PPPL ENGINEERING CHANGE NOTICE (ECN) ECN # 5121

ECN TITLE: Port Attachment Weld Deviation Request

AREA OR PROJECT: NCSX

DRAWING(S) AFFECTED NUMBER:	NEW Revision	TITLE
SE120-004 (Sheets 4 through 19)	See RLM Comment	Vacuum Vessel Period Inspection and Leak Check Assembly

Sketch of MTM Weld Concept

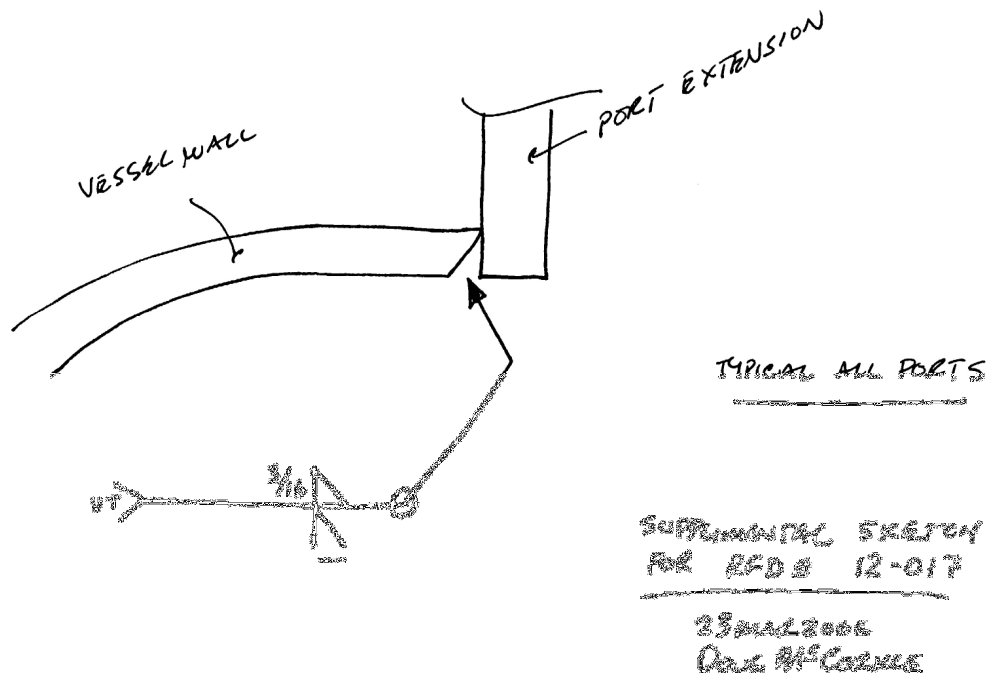
MTM used a different method for welding the port extensions to the vessel for VVSA segments #1 and #2. NCR19464 approved this deviation for “use as is” for VVSA segments #1 and #2. The deviation request approved by RFD-12-017 authorized this different method for welding the port extensions for VVSA segment #3.

This method for attaching the port stubs uses a process by which the majority of the joint is filled in from the inside vessel surface, then we grind the outside (root side) until all irregularities are removed, and apply a fill pass and a cover pass (which creates the 3/16 fillet) on the exterior side (see attached sketch).

- Round ports - cutting the hole in the vessel to the o.d. size of the tube and welding full penetration from the vessel interior (ground flush) with a continuous fillet weld around the tube exterior.
- Ports 4, 12, NB - welded the exterior fillet as a continuous fillet opposed to the specified intermittent weld.
- Clevis bosses - added a 3/16 fillet to the exterior side of the joint.

MTM alternate methods provide equal or better welds.

RFD-14-017 authorized this deviation for the VVSA segment #3.
